Coos County Planning Board

NOTICE OF DECISION

Application for Site Plan Approval: Balsams Ski Area

NH Route 26, Dixville

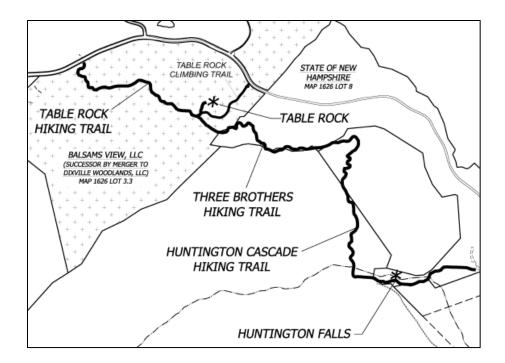
- f. The Applicant shall continue to allow public access to Cascade Brook and Table Rock via foot paths. The general location of the trails subject to this requirement is shown on the next page; however, the Applicant may require portions of these trails to be relocated.
